Project	IEEE 802.16 Broadband Wireless Access Working Group < http://ieee802.org/16 >	
Title	Support for Miscellaneous Functions in Relay MAC Header	
Date Submitted	2007-09-08	
Source(s)	Zhifeng (Jeff) Tao, Jinyun Zhang Mitsubishi Electric Research Lab	Voice: 1-617-621-7557 E-mail: tao@merl.com
	Toshiyuki Kuze Mitsubishi Electric Corp	
Re:	Response to the IEEE 802.16 Working Group Letter Ballot #28 (i.e., IEEE 802.16j-07/043).	
Abstract	This contribution proposes more detailed bit assignment in relay MAC header.	
Purpose	To adopt the bit assignment proposed herein into IEEE 802.16j.	
Notice	<i>This document does not represent the agreed views of the IEEE 802.16 Working Group or any of its subgroups. It represents only the views of the participants listed in the "Source(s)" field above. It is offered as a basis for discussion. It is not binding on the contributor(s), who reserve(s) the right to add, amend or withdraw material contained herein.</i>

Support for Miscellaneous Functions in Relay MAC Header

Figure 2: MPDU on relay link.

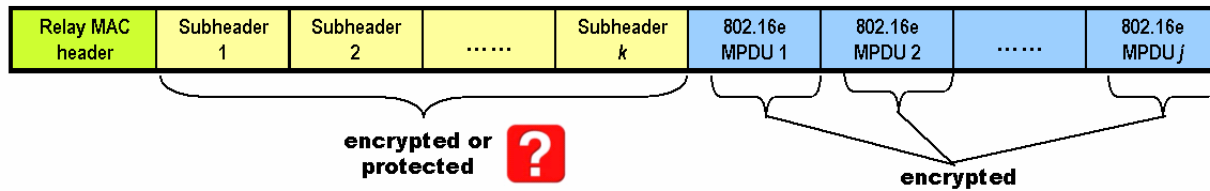
On relay link, a few subheaders (e.g., fragmentation, packing, QoS, allocation) may appear immediately after the relay MAC header and before the concatenated individual MPDUs. We call them *relay subheaders*. This is illustrated in Figure 2.

Each individual MPDU in the concatenation may have been encrypted. However, it is not clear from the current baseline whether the relay subheaders are protected.

The final design decision regarding the protection of subheader has implication not only on key distribution protocol, but also on relay MAC header design.

- If relay subheaders can be encrypted, the intermediate RS may need to have the key, because it needs to read the content of the subheader (e.g., fragmentation subheader, QoS subheader, allocation subheader, etc.).
- If relay subheaders can be encrypted, the relay MAC header then need to indicate whether the encryption is applied on the ensuing subheaders or not, and what the encryption key sequence is.

That is, in order to support encryption of relay subheaders, we will need to bring *EC bit* and *EKS field* back into the relay MAC header.
